**The Woodlands Off-Site Sanitary Lift Station, Force Main & Gravity Sewer Line A (RFCSP)**

**Solicitation Number: CO-00682**

**ADDENDUM 3**

**November 15, 2023**

RELAY BT1 ENERGIZED UNDER NORMAL CONDITION, AND DE-ENERGIZED UNDER OVERTEMP CONDITION

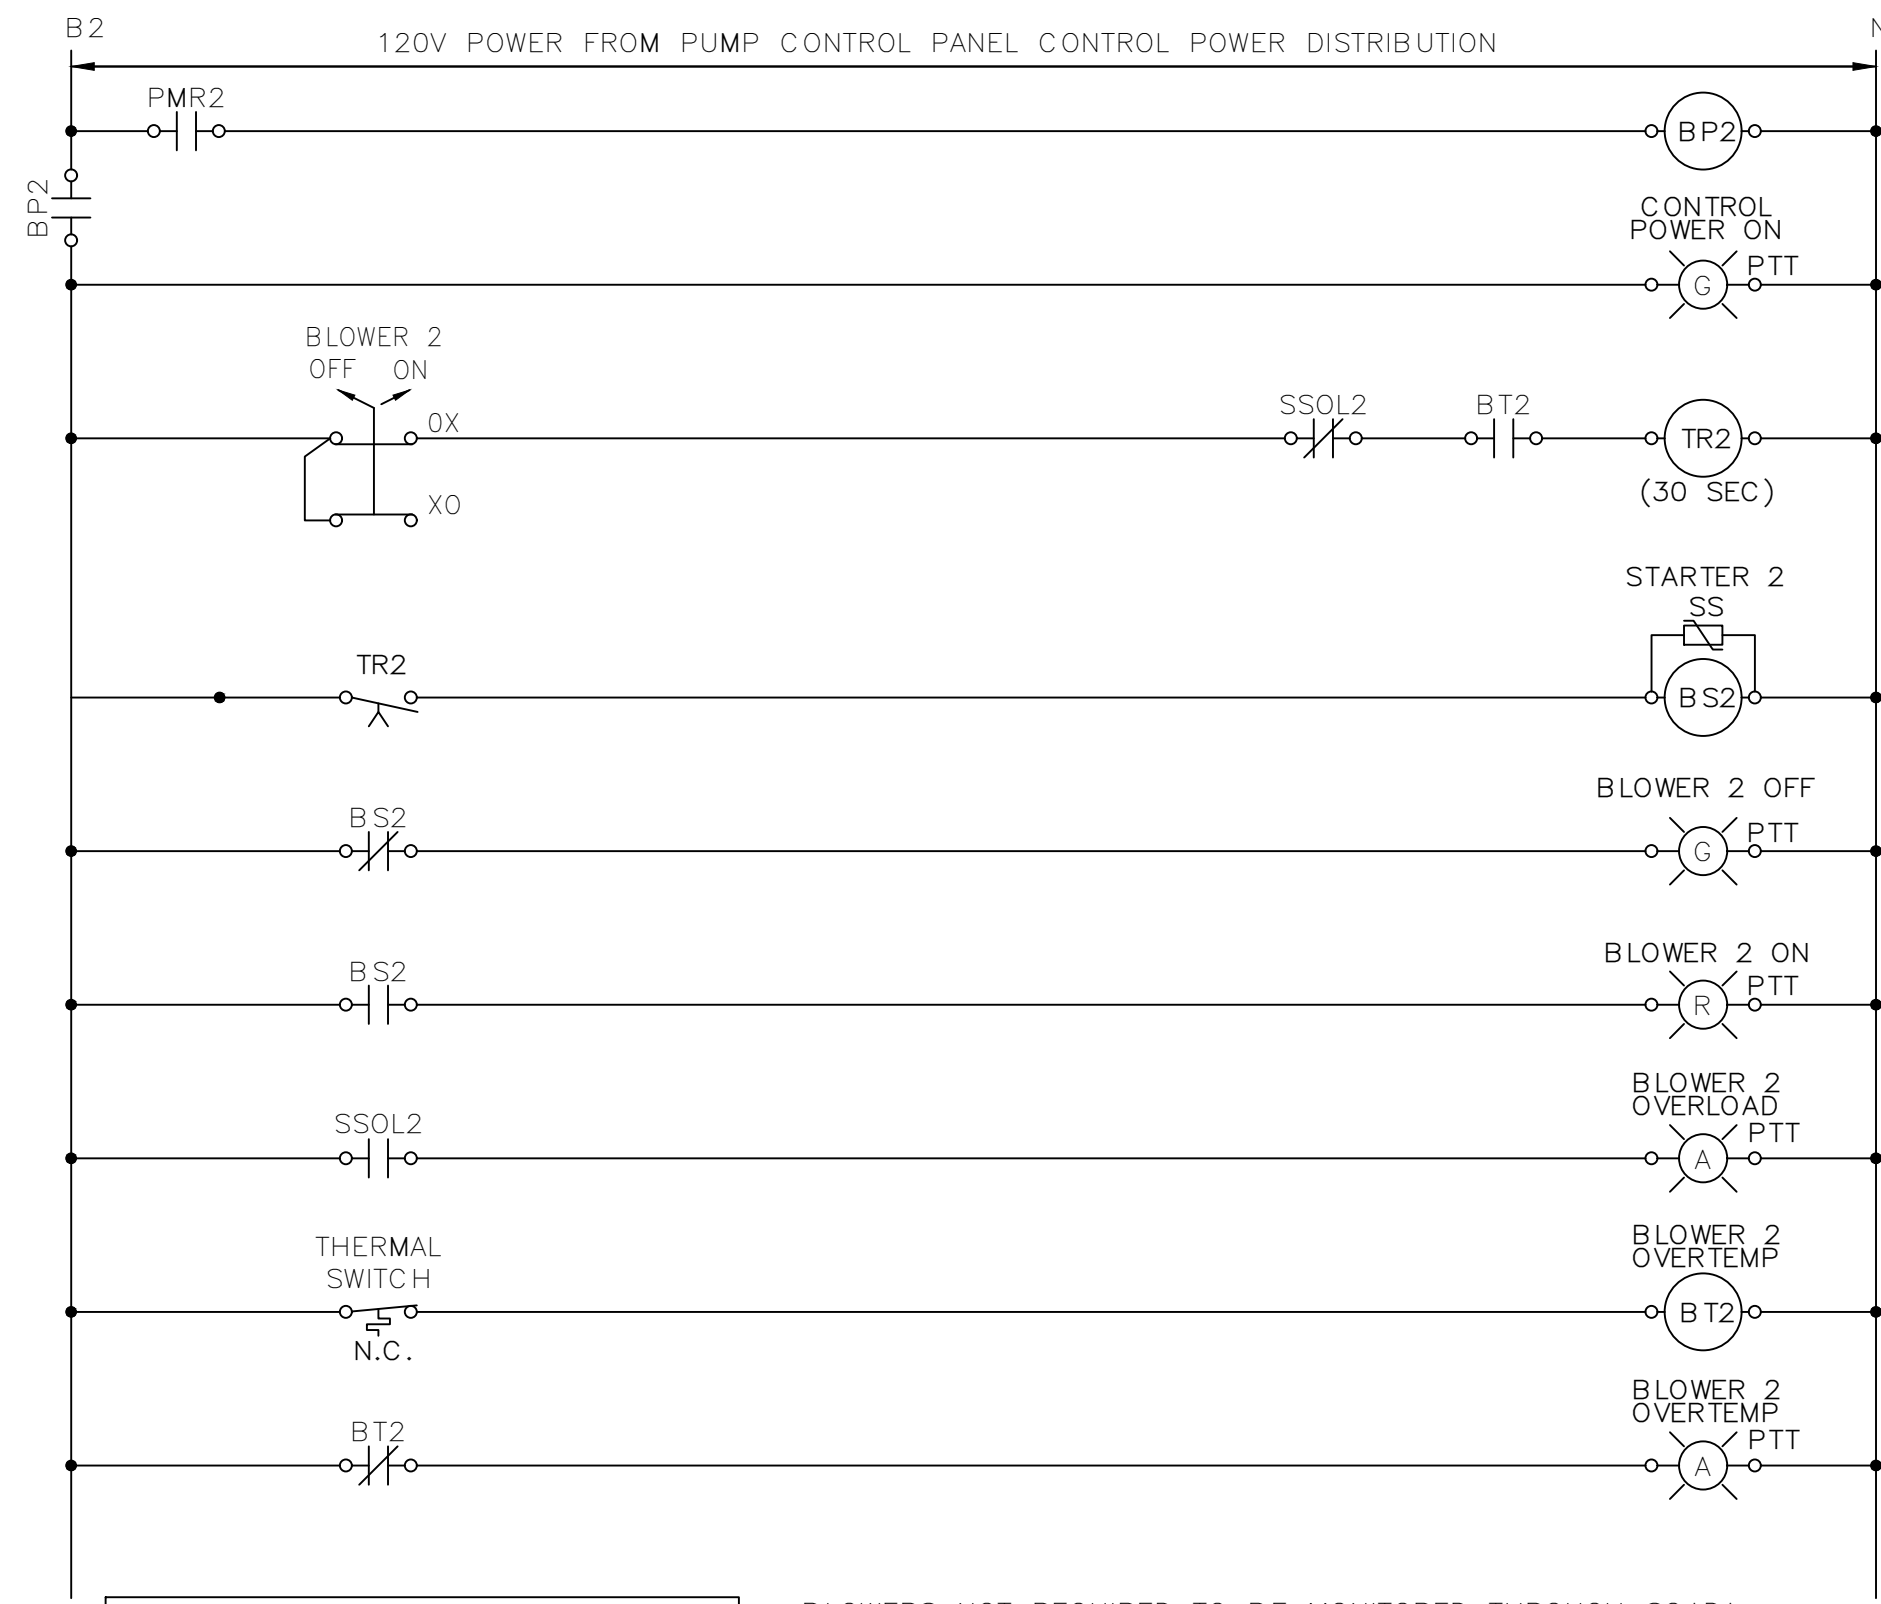
12. **Question:** On drawing E-4 keynote 9 it says the SCADA cabinet shall be a NEMA 12 wall mount enclosure. On drawing E-21 note 5 calls out for the enclosure to be NEMA 4X 316SS painted white. Which is correct?

**Answer:** *Since this will be installed indoors, NEMA 12 is acceptable. See Changes to the Plans #2. The previous sheet E-21 has been revised accordingly and re-issued as E-22 due to a previous duplication of sheet numbers.*

JOB NUMBER:	SA190-0404.426
SHEET NO.:	GS6.2

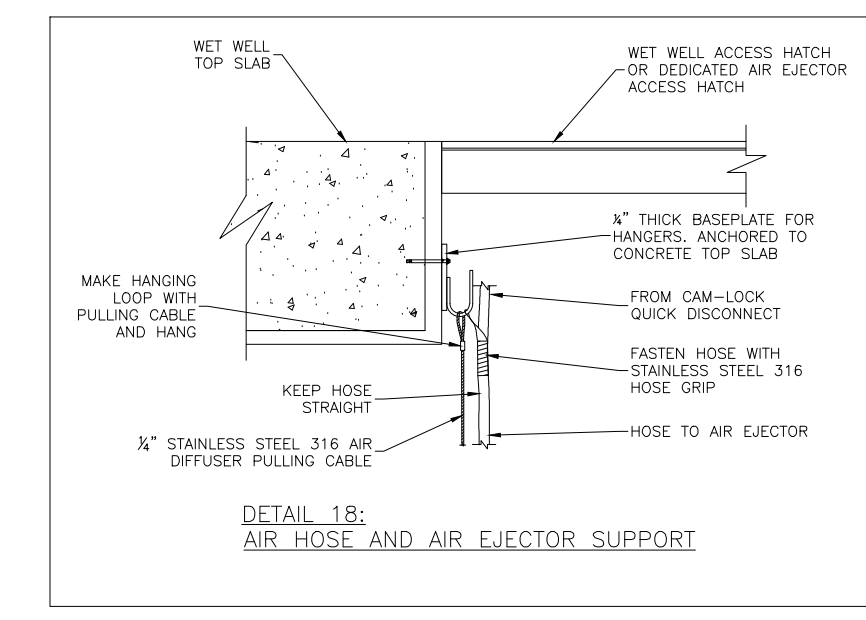
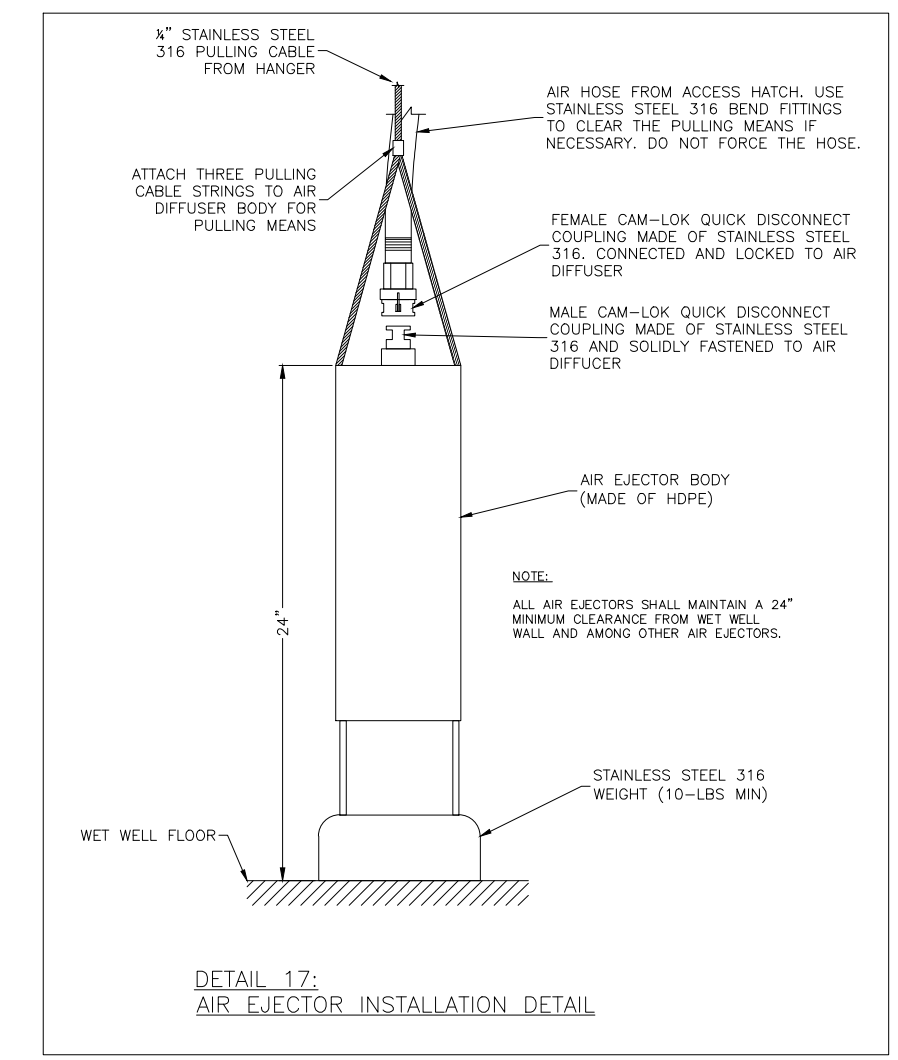
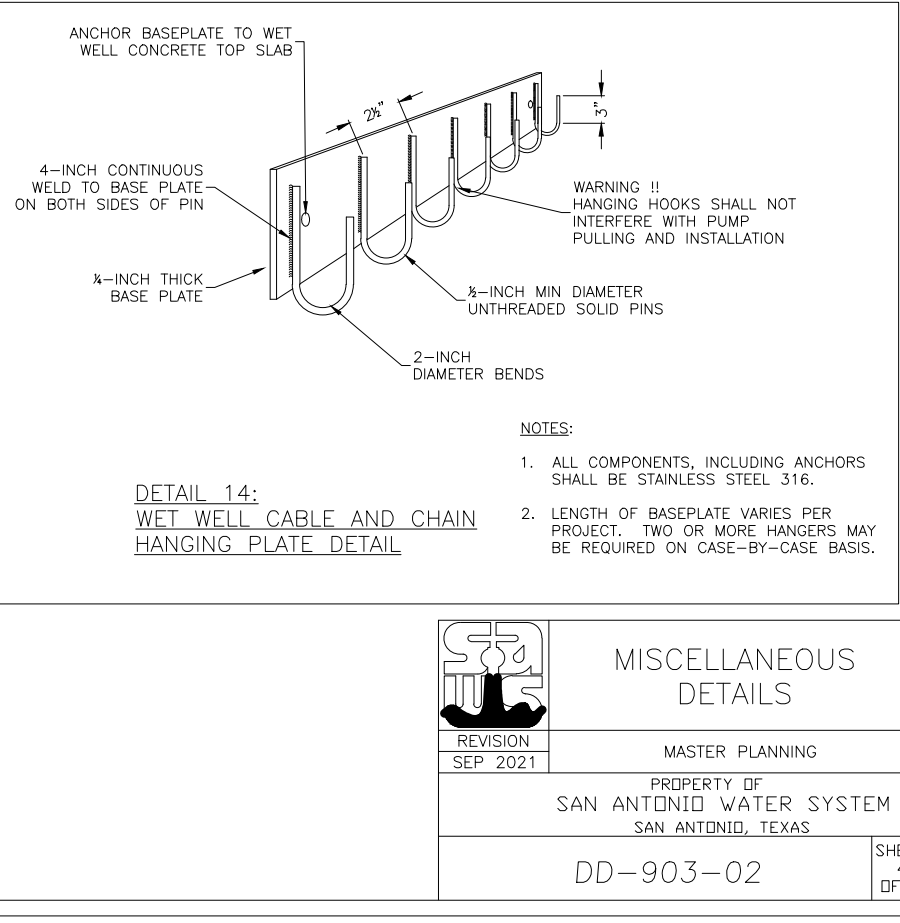
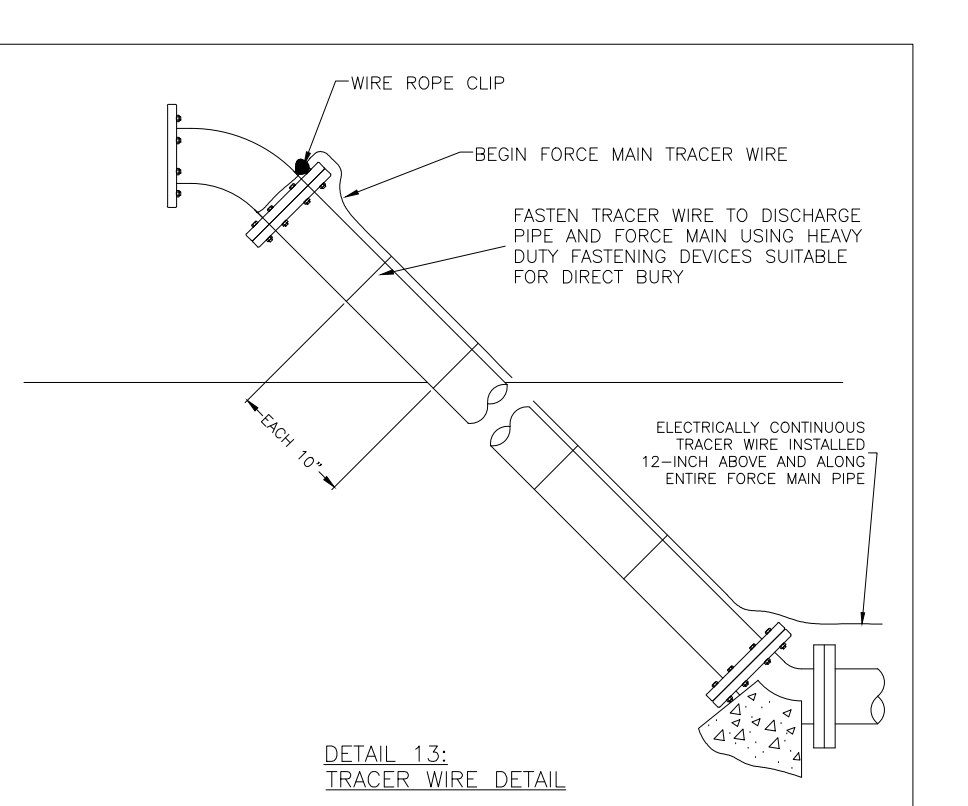
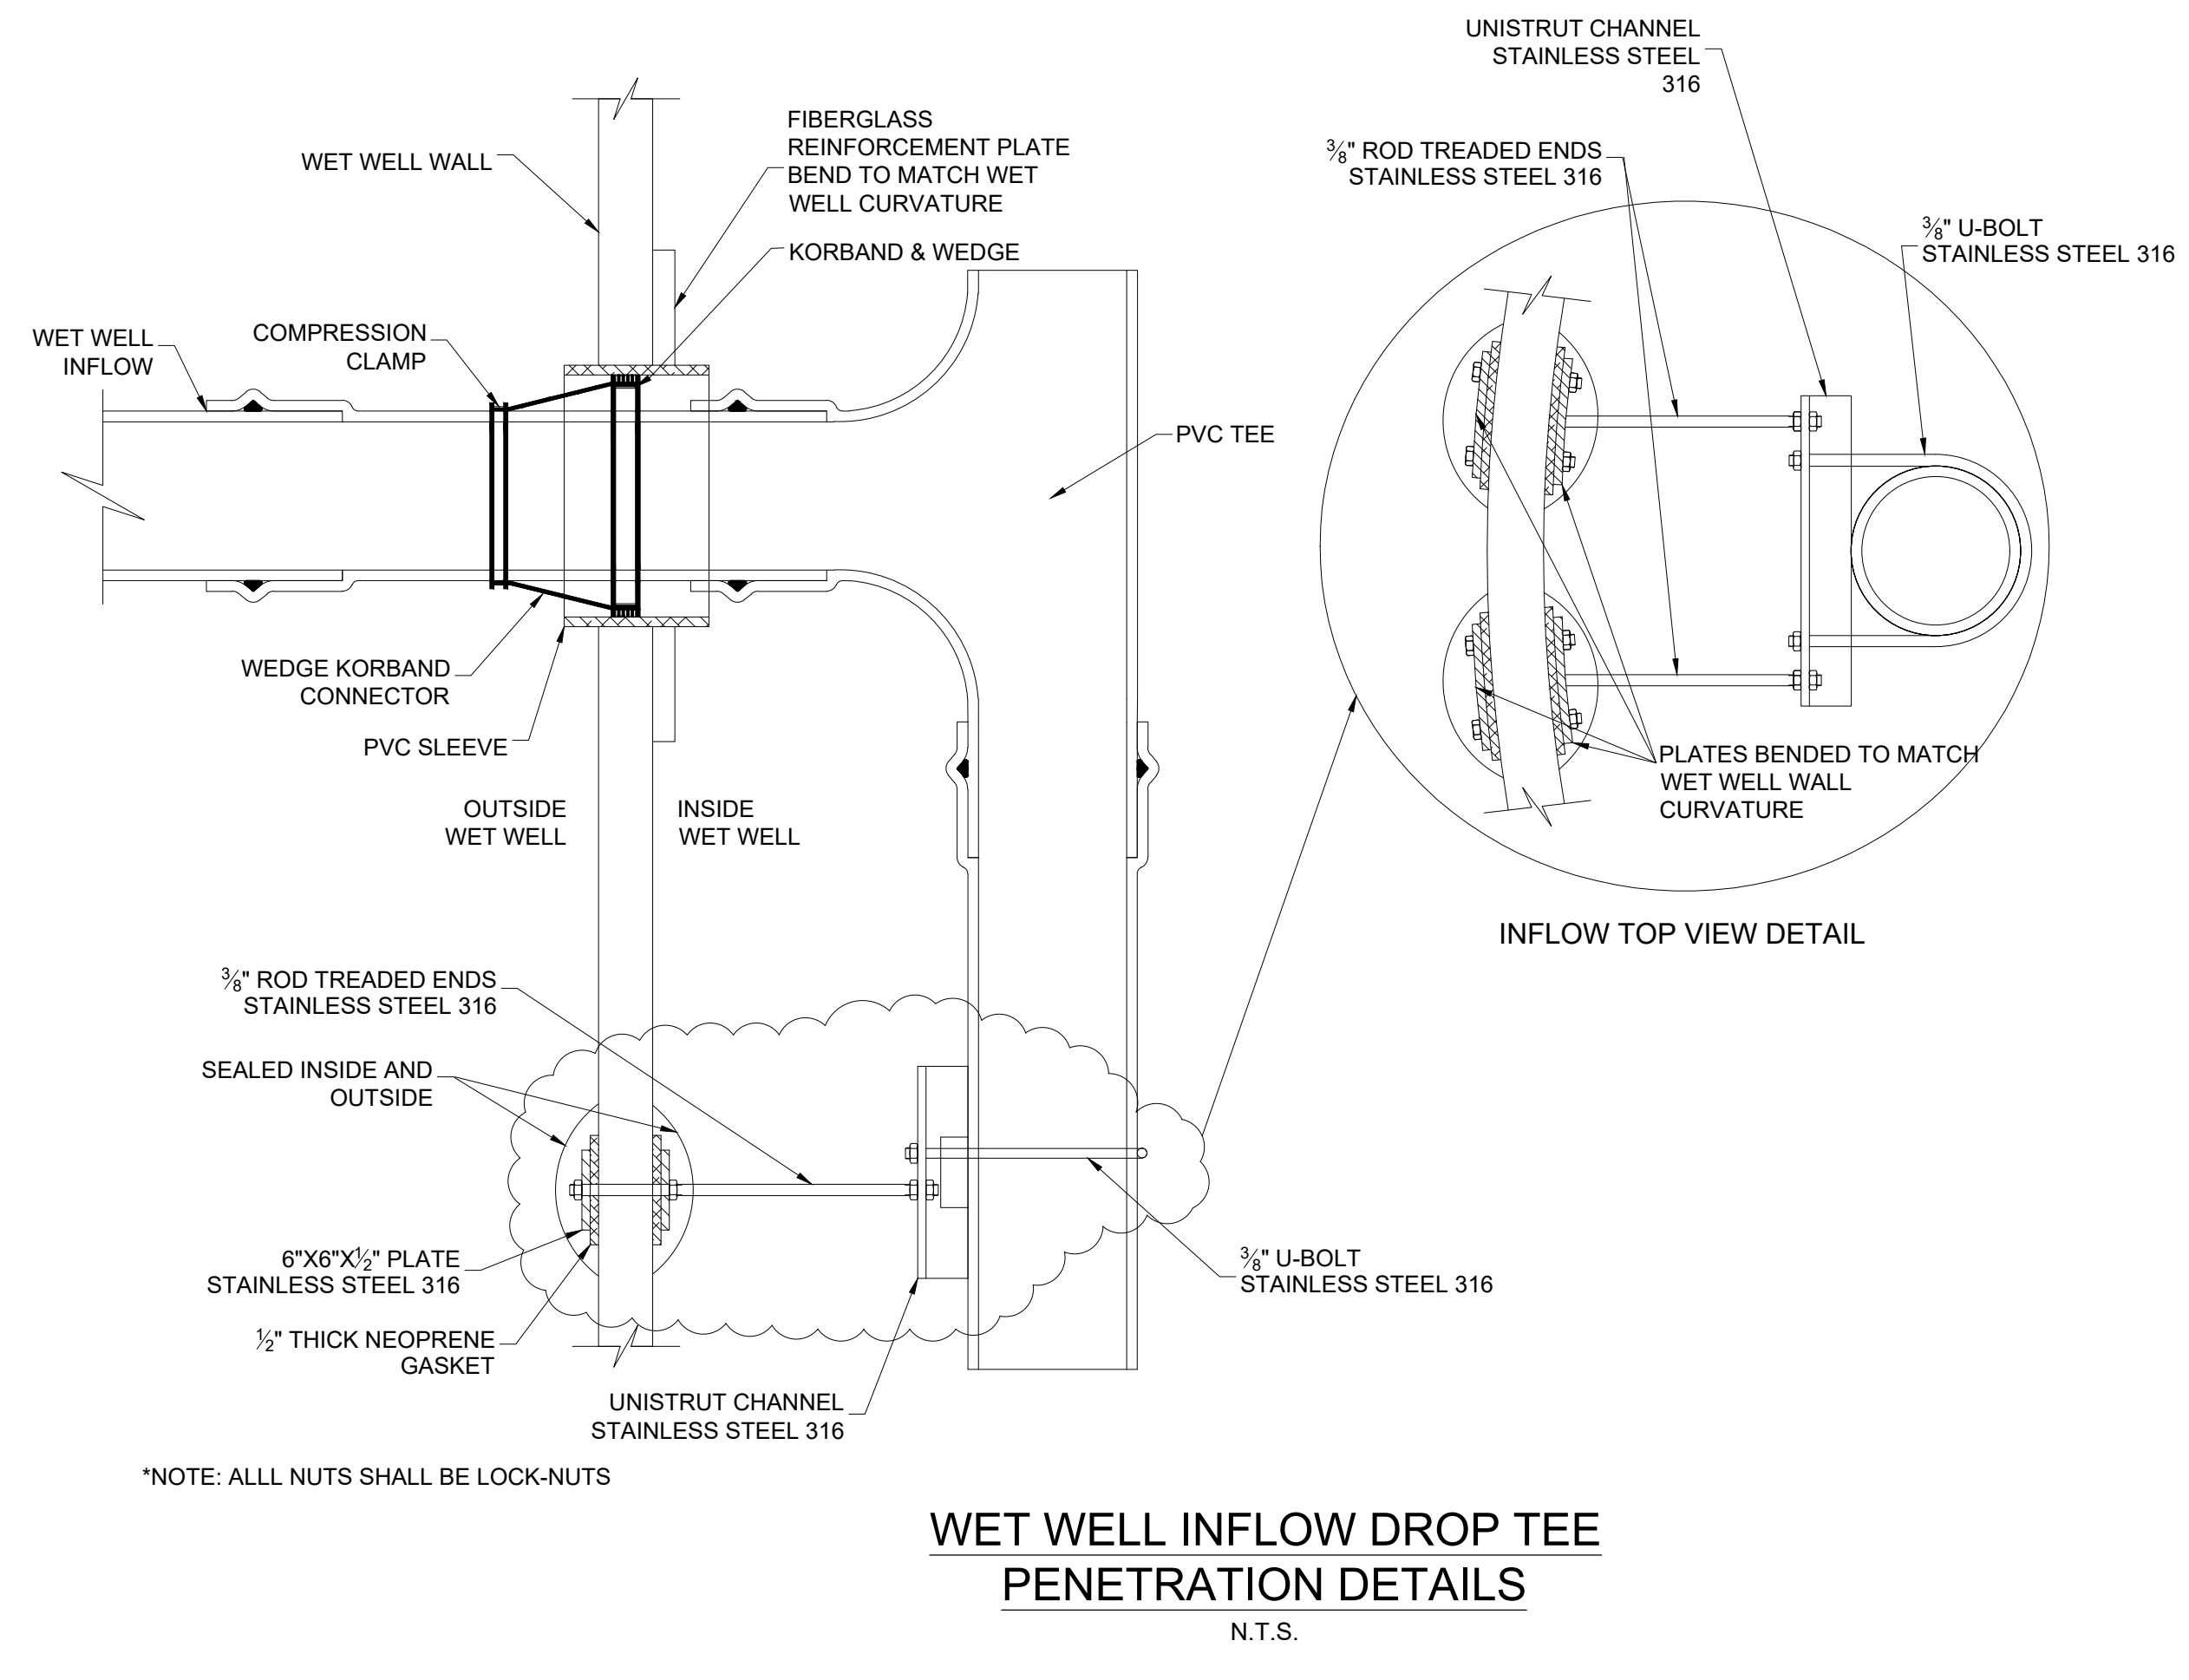
15. **Question:** Reference sheet no. GS6.2 detail 19: supplemental drum scrubber. Do you have a schedule or specs for this? If not, can you confirm air flow? How many of these are required?

**Answer:** *See Changes to the Plans #3. Sheet GS6.2 has been revised to remove reference to a supplemental drum scrubber, which is not required.*
